**CONSTRUCTION CONTRACT CHANGE ORDER NUMBER:** \_\_\_\_\_

CCSJ:	<u>0921-02-321</u>
Project:	<u>STP 2021(256) MM</u>
Highway:	<u>Mile 3 N</u>
County:	<u>Hidalgo</u>
District:	<u>21-Pharr</u>
Contract Number:	<u>C-20-294-02-23</u>

## Change Order #5 Mile 3 N Road

Project: Mile 3 N Road  
Project #: STP 2021 (256) MM  
Contract: C-20-294-02-23  
CSJ: 0921-02-321  
Limits: Tom Gill Road to FM 492 (Goodwin Road)

**MILE 3 ROAD  
PLAN AND PROFILE  
STA. 250+50 TO STA. 255+50**

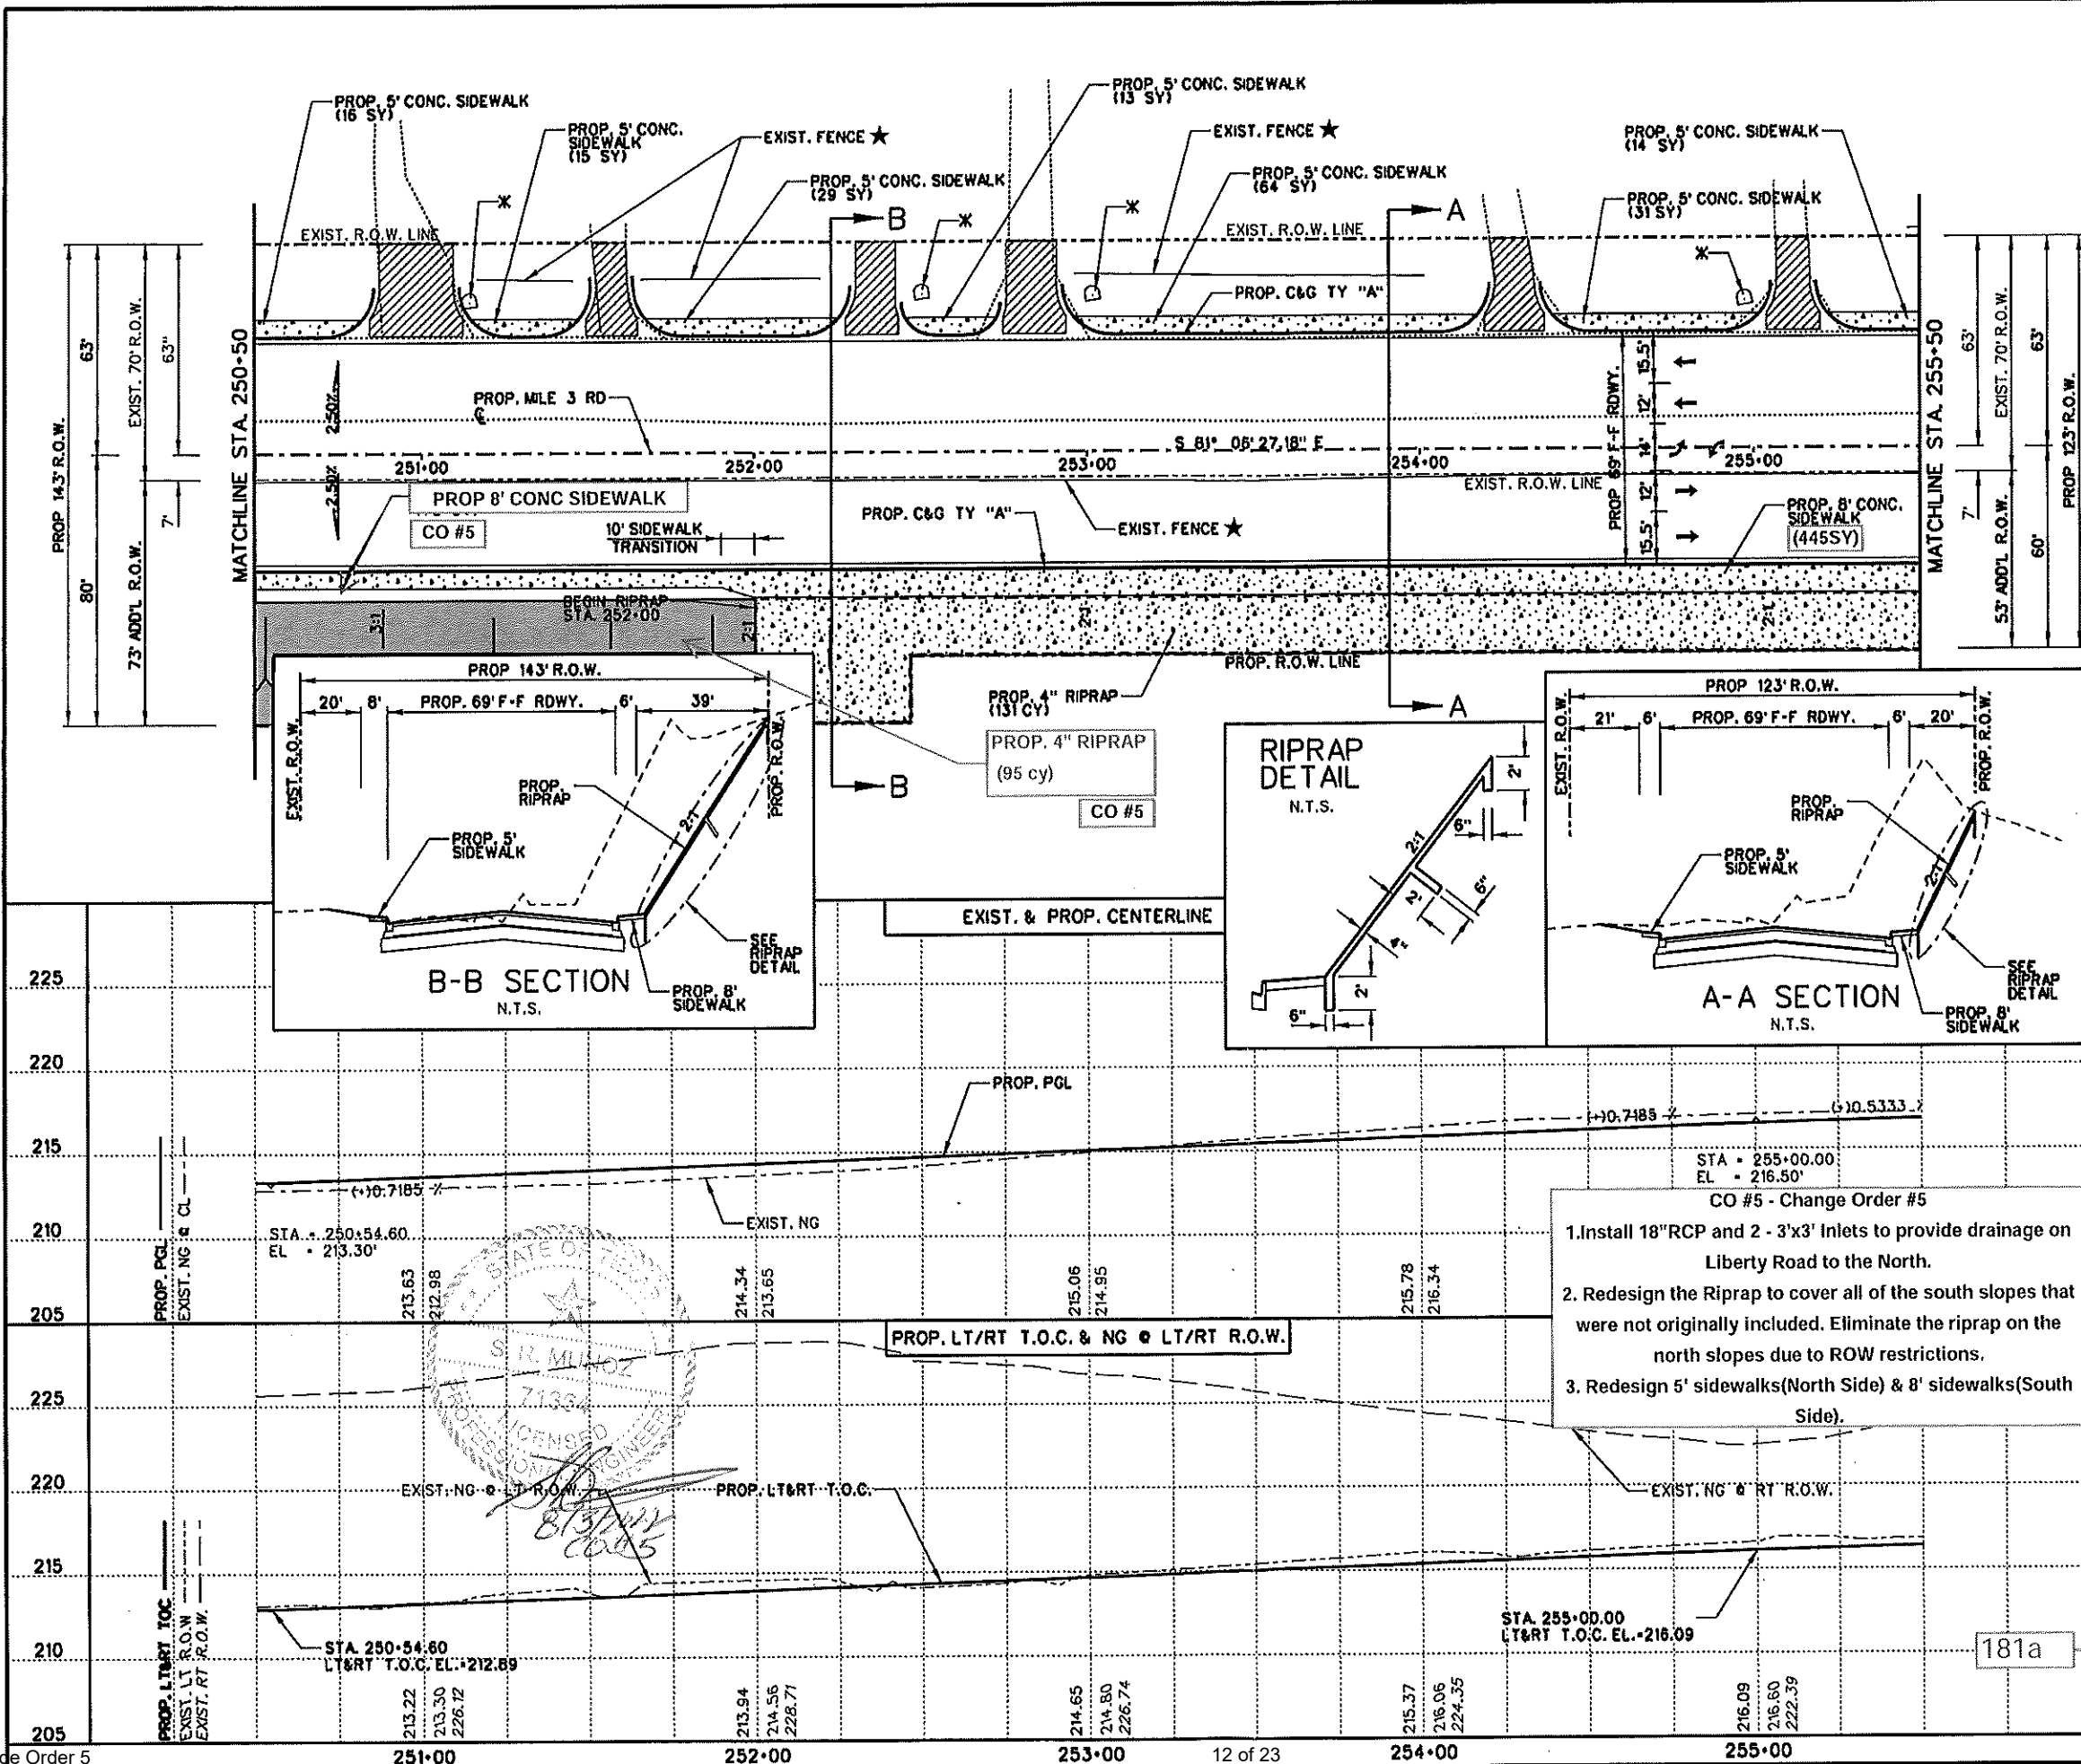
- CO #5 - Change Order #5**
1. Install 18" RCP and 2 - 3'x3' Inlets to provide drainage on Liberty Road to the North.
  2. Redesign the Riprap to cover all of the south slopes that were not originally included. Eliminate the riprap on the north slopes due to ROW restrictions.
  3. Redesign 5' sidewalks (North Side) & 8' sidewalks (South Side).

MILE 3 ROAD  
 PLAN AND PROFILE  
 STA. 260+50 TO STA. 265+50

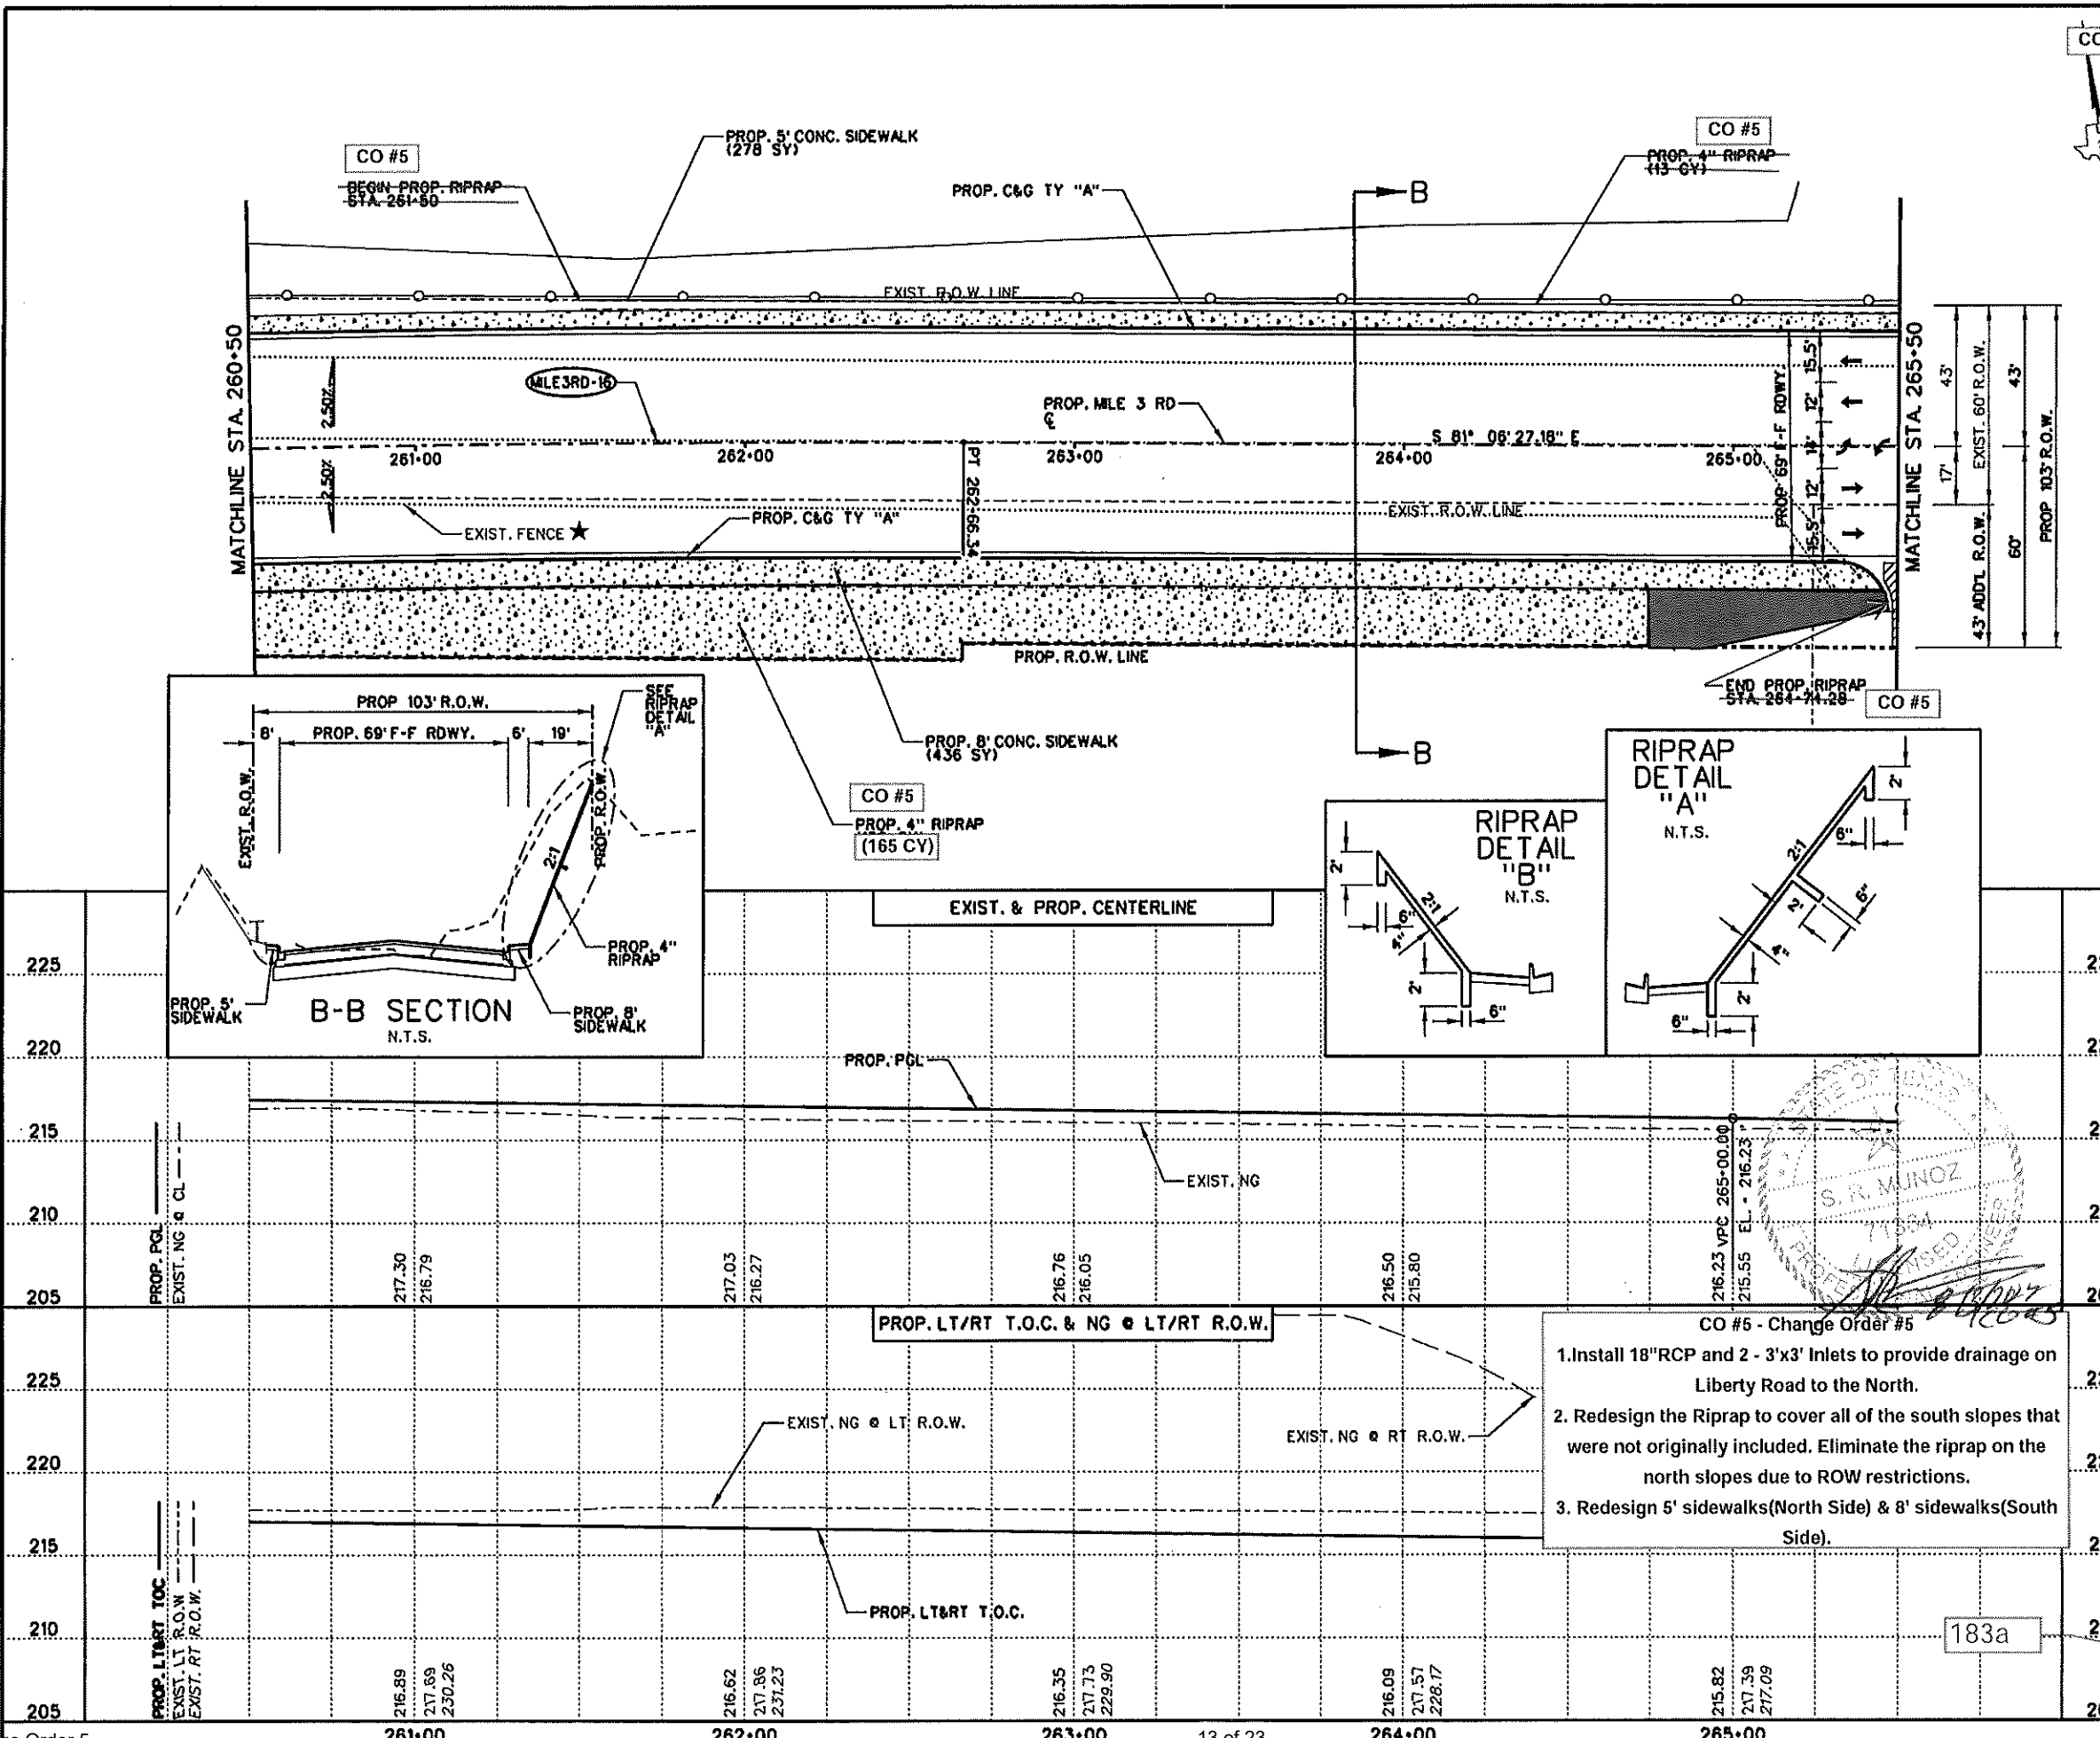
- CO #5 - Change Order #5
- Install 18" RCP and 2 - 3'x3' Inlets to provide drainage on Liberty Road to the North.
  - Redesign the Riprap to cover all of the south slopes that were not originally included. Eliminate the riprap on the north slopes due to ROW restrictions.
  - Redesign 5' sidewalks (North Side) & 8' sidewalks (South Side).
